CITY OF FREDERICKSBURG HISTORIC REVIEW BOARD

TUESDAY, JUNE 15, 2021

7. CERTIFICATE OF APPROPRIATENESS APPLICATIONS

Application Number: 21-27
Date: June 15, 2021
Address: 201 S Orange
Zoning: R2
Owner: Heinrich & Brenda Boenig
Applicant: Whitney Koch of Mustard Design
Rating: medium
Proposal: remove non-original lattice and replace with front porch arbor

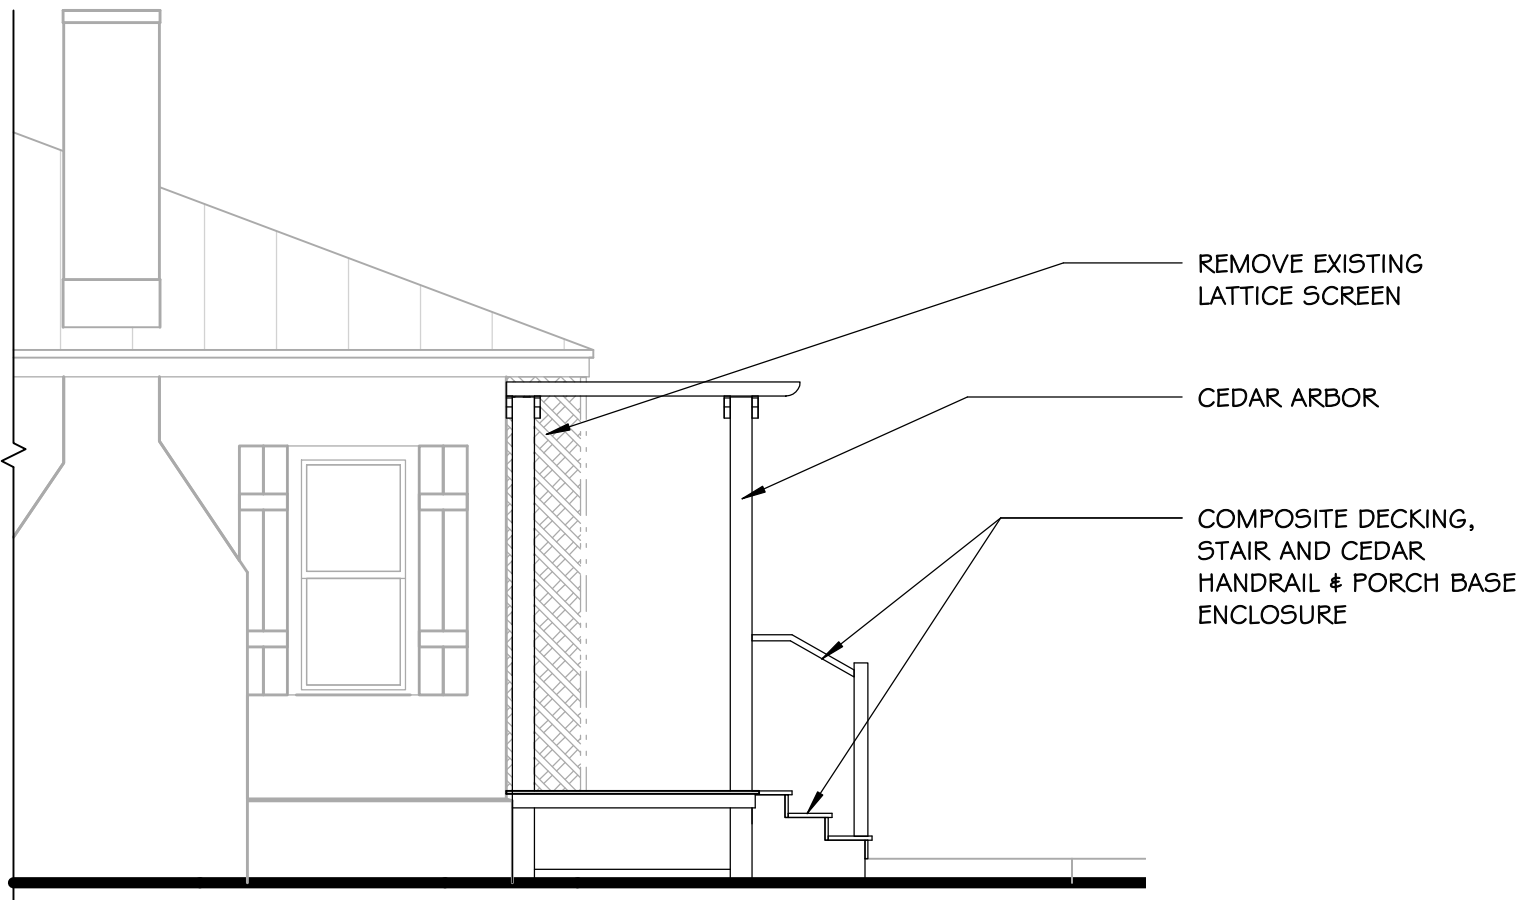
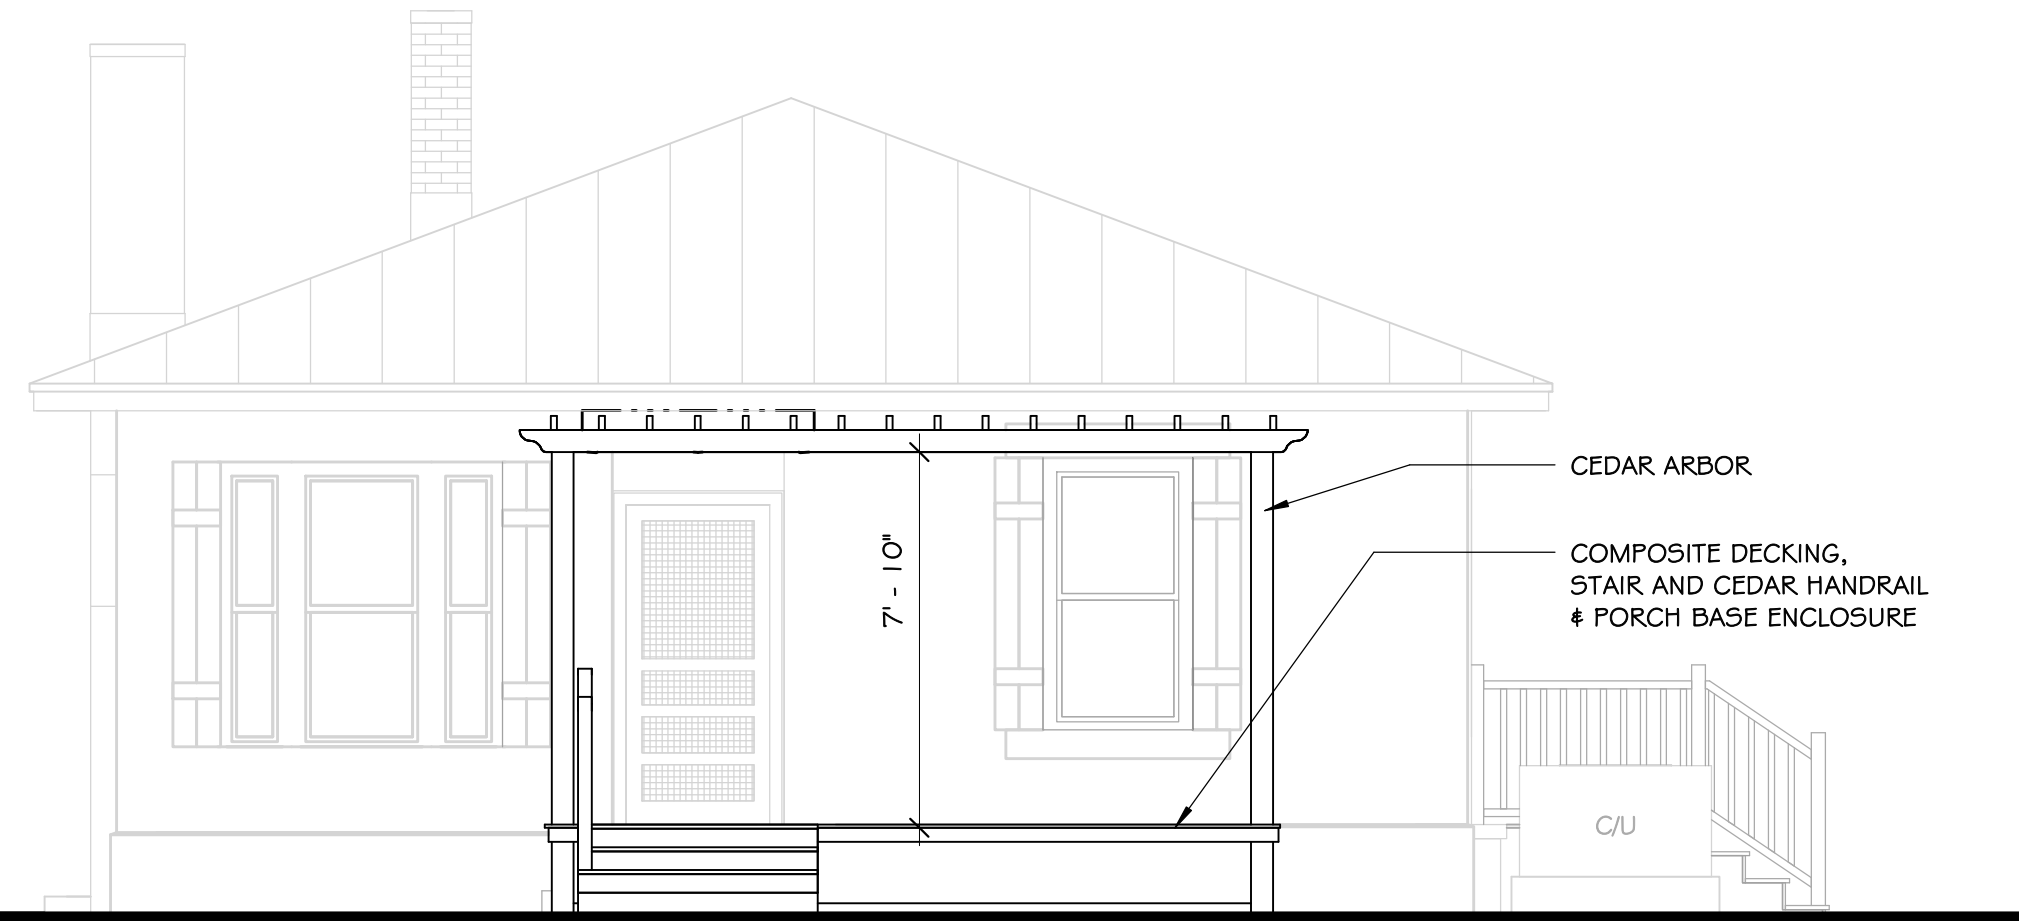
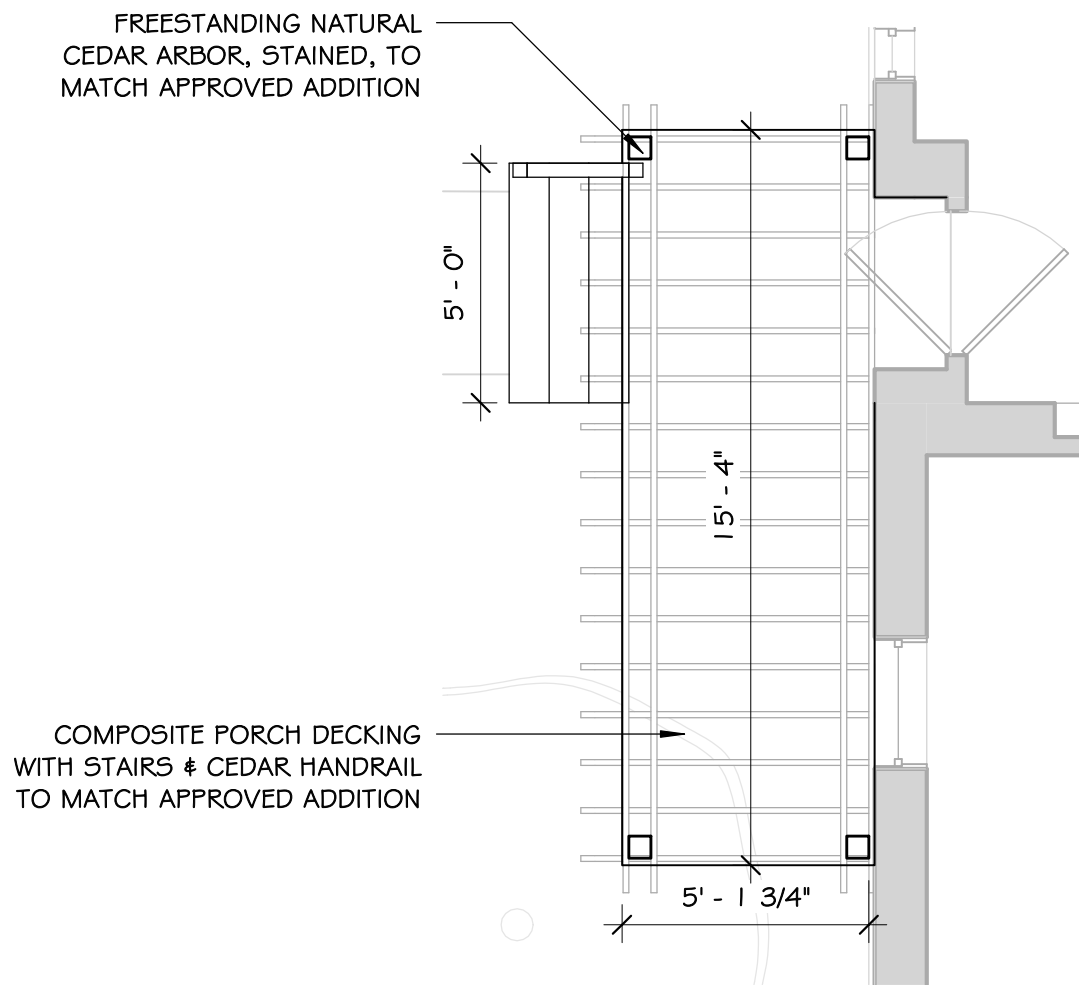
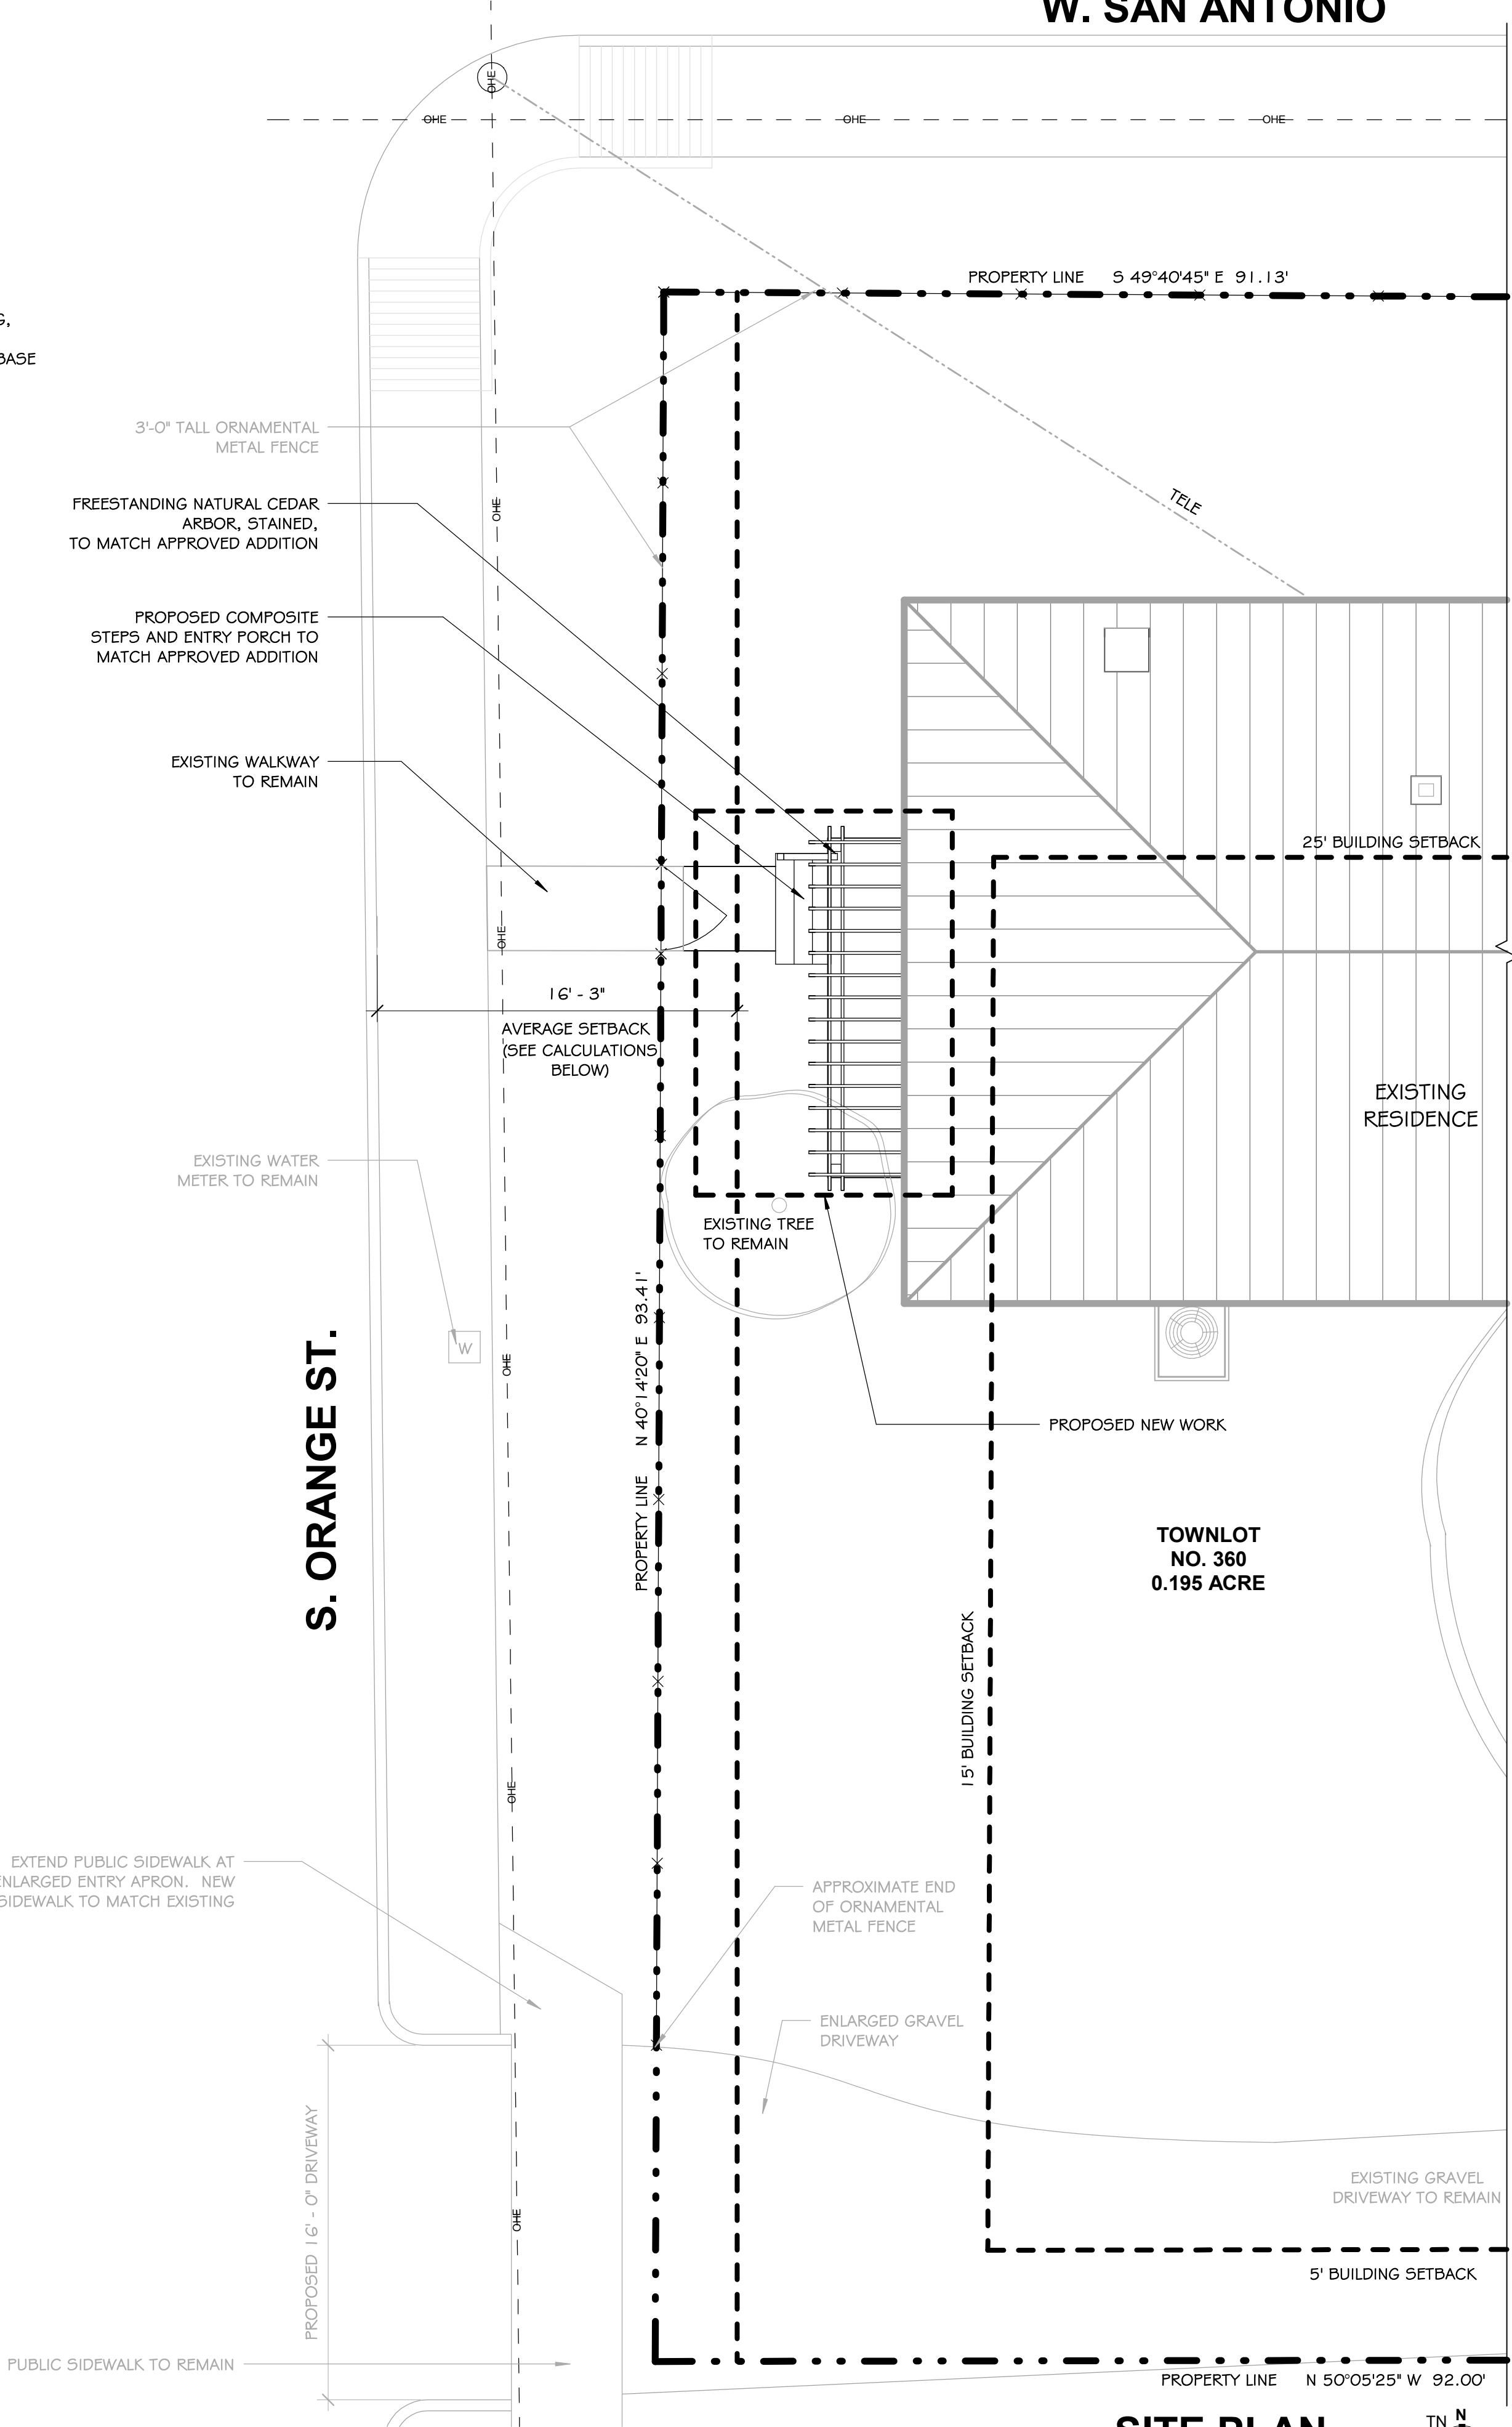
2. A character-defining feature of a Hipped-Roof Square-Plan house is that the porch is recessed under the roof. This feature was changed in the 1940's. The lattice "stoop" has been present since the 1950s.

The front façade and front porch tell a lot about the style and age of a house. The original porch was inset and closed-in more than 60 years ago. The modern arbor is not appropriate for the style of the house. If a new porch feature is added it should be positioned in front of the original porch and should not cover the original window opening on the right of the front door. This recommendation is in keeping with SOI #4, 9 and 10.
